Environmental Review Team Report

Deer Run Estates

Willington, Connecticut

February 1983

Topography

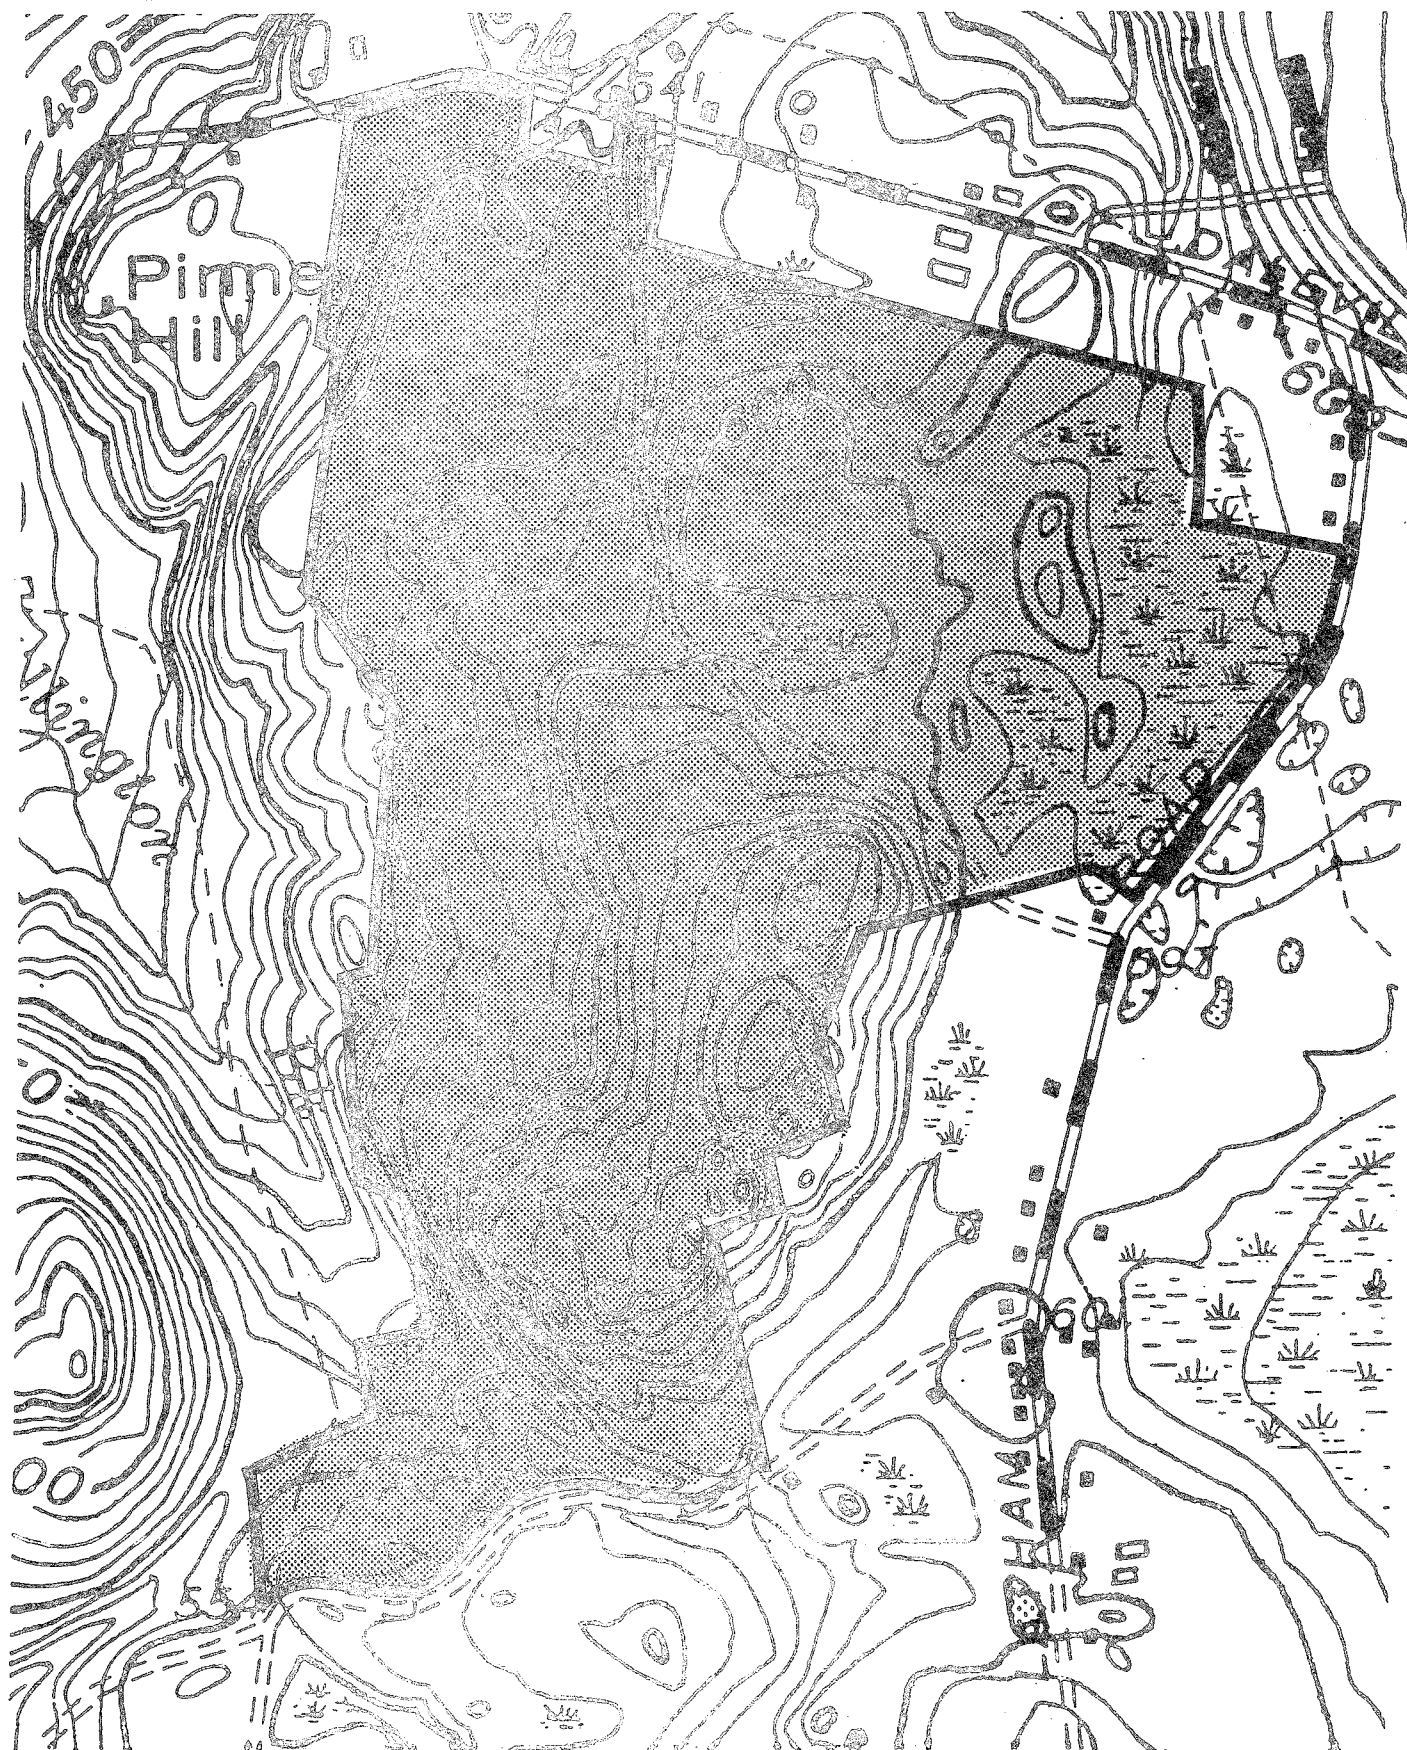
in South Willington. The elevation varies from a low of approximately 550' above mean sea level to a high of 660' above mean sea level. There is a large wetland area comprised of \pm 30 acres in the eastern portion of the site.

The site is a combination of moderately to steeply sloped areas and relatively flat benches (see accompanying illustration). The steepest areas can be found throughout the southern half of the property, particularly along Burt Latham Road (see accompanying illustration). Also, there is a steeply sloping area beginning about 300' from the intersection of the proposed access road with Pinney Hill Road. The remaining portion of the property has moderate to gently sloping areas with the (predominantly) flatter areas in the middle section of the parcel.

Drainage Areas

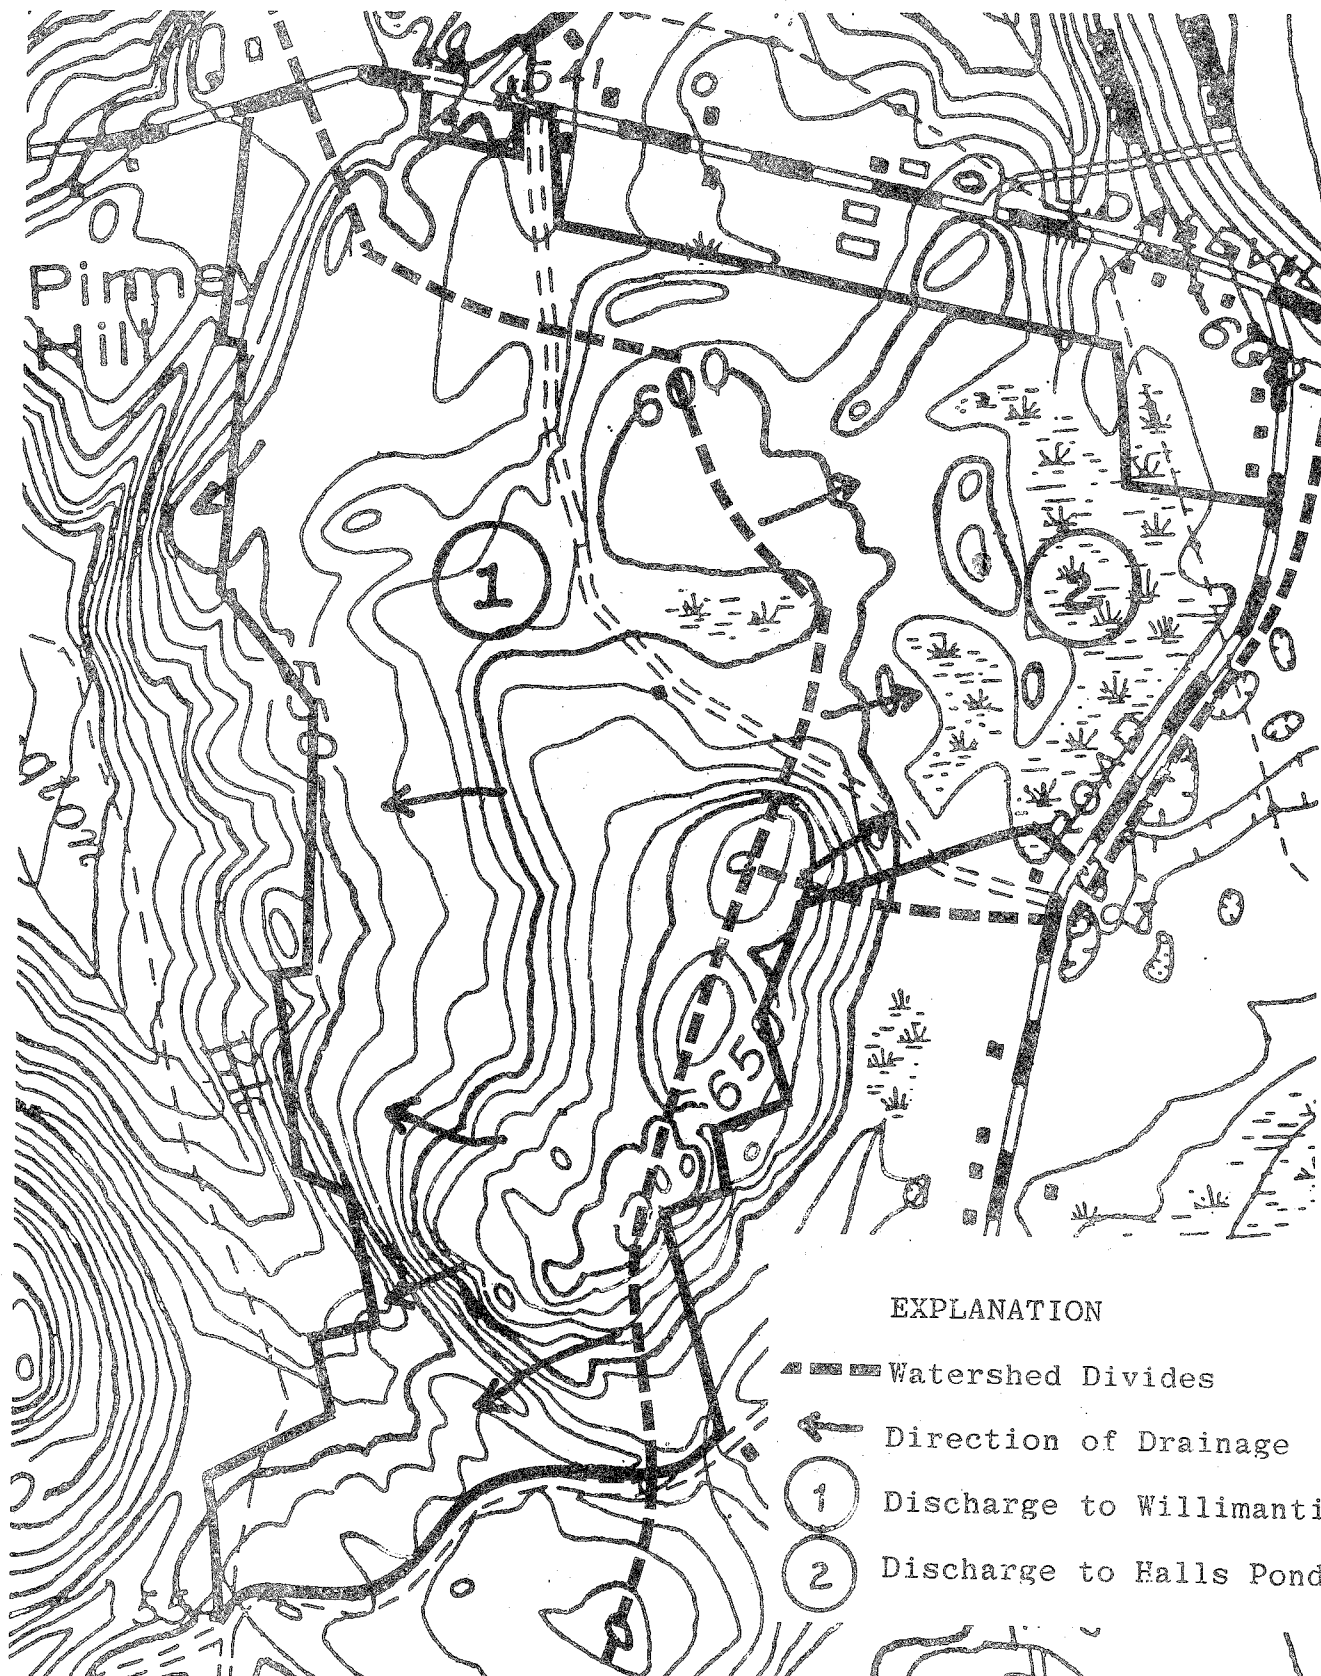
The watershed for the Deer Run Estates site is divided approximately in half in a north-south direction (see accompanying illustration). Runoff from the eastern portion (Part A) of the property flows northward through a large wetland area, from which it is channelled northwest via a small, unnamed stream where it discharges into Hall's Pond. The western portion of the property drains westward into the South Willington Brook which empties into the Willimantic River. The major drainage basin divide is located to the east of the property.

Development of the site will cause an increase in the volume of runoff, however, the consulting engineer indicates that stormwater runoff will be retained within the site. These increases would be caused by such factors as removal of vegetative matter, compaction of soils in disturbed areas and the creation of impervious surfaces such as roofs, paved driveways and roads. For the most part, runoff will be carried either naturally or artificially into wetland areas on the site. Plans indicate that energy dissipators to reduce the velocity of runoff will be installed on Lots 12 and 14. All other points of discharge will have flared ends with 4" riprap. Permanent drainage easements should be considered on lots 7, 8, 10, 12 and 14. The drainage outlet at lot 14 does not involve a great volume of water, however it is on a 21% slope. The developer should consider moving this outlet 150 feet to an area of more gentle slope.

Special attention should be directed to the amount of runoff discharged into the wetland areas, its overall affect on the wetland areas, and maintenance measures to be taken, should a significant buildup of sediment occur at the discharge points.

Vegetation

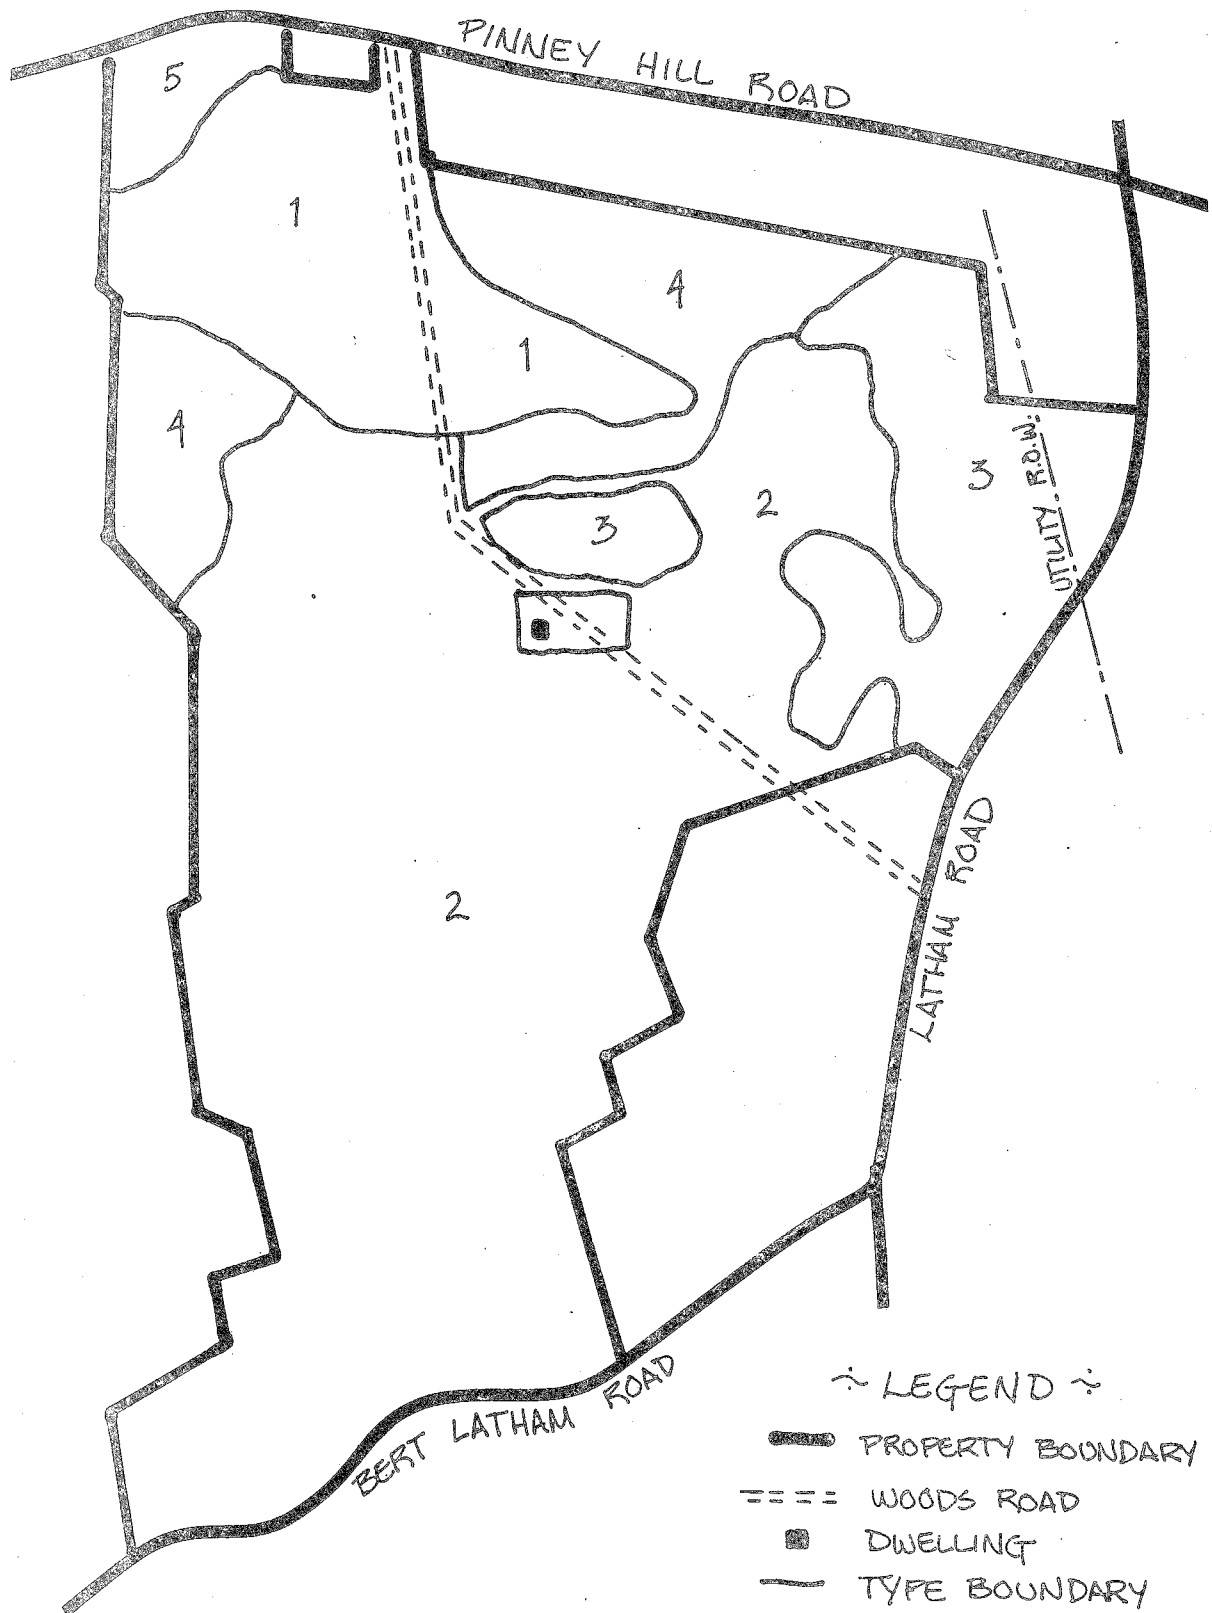
The tract which is proposed for subdivision can be divided into five vegetative types (see map). These include a natural white pine stand which totals 32 acres; a mixed hardwood stand which totals 120 acres; two hardwood swamps totaling 30 acres; two softwood-hardwood stands totaling 23 acres; and open areas with fields, Christmas trees and an open house lot of 6 acres.

Vegetation Types 1, 2, and 4 have all been harvested within the last 10 years. As a result of the harvest, Vegetation Type 1 is a healthy and aesthetically pleasing pure white pine stand, Vegetation Type 2 a poorly stocked mixed hardwood stand with several culls and undesirable trees, and Vegetation Type 4 is healthy and still somewhat crowded with too many trees per acre. In Vegetation Type 1, if more than one-fifth of the trees are removed in linear clearings or large open patches are created for houses the risk of wind throw and breakage from ice and snow will be increased greatly. The high risk culls in Vegetation Type 2 should be removed for safety purposes. Impact on Vegetation Type 3 as a result of roads or building should be minimal, as long as present drainage is not disturbed, however these wetland areas provide water and shelter for wildlife on the property. Disturbance of the vegetative diversity on this property would negatively impact the large deer population and affect birds, small mammals and fur beavers, although not severely.

Alterations in wetland areas which permanently raise or lower the water table will eventually have a negative impact on the vegetation in these areas. Raising the water table will drown roots causing widespread mortality in the trees, shrubs and herbaceous vegetation now present. Lowering of the water table will cause mortality from drought. Lowering of the water table will also deprive local wildlife of sources of water. Death of trees in general as a result of water table disturbance would result in reduced nesting areas, lack of cavity trees for homes, and reduced shelter and hiding areas. Proper construction methods near wetlands will create minimal impact on the wetlands.

Windthrow and tree breakage is a potential hazard in Type 1. White pine is subject to windthrow for 2-3 years after tree removal from harvesting due to shallow root systems and the tree height. White pine growing closely in a stand depend on each other for support. Type 1 is now properly stocked and growing well. Roots systems are firm in the soil. Opening for buildings or roads would create soil disturbance and open this stand up to greater windthrow and breakage potential.

In Type 2, the mixed hardwood stand is presently poorly stocked and unhealthy. The forest is presently unproductive. To stimulate productivity, a thinning to remove culls and poorly formed specimens can be performed. This type of harvest, a Shelterwood Regeneration harvest, would create openings in the forest canopy, by removing the cull and undesirable trees, to stimulate seedling production. The harvest would result in stump sprouts creating food browse for deer and seed drop in future years resulting in acorns and other seed for deer, squirrel and some birds. Presently there is little food for deer as they have browsed over the area for the past few years. Material to be removed would be 5-6 cords of fuelwood per acre.

In Type 3, the wetlands should not be disturbed as these areas are too wet to allow harvesting.

In Type 4, the softwood-hardwood type, is somewhat crowded with too many trees per acre. This area can be converted to almost pure white pine over the next 20-30 years. Pine would be a more suitable species to grow on the well-drained soils. To continue the conversion to white pine and encourage the pole-size white pine in this type the poorest hardwoods (cull and undesirable growing stock) can be removed in an improvement thinning. This type could presently yield 5 cords of fuelwood per acre.
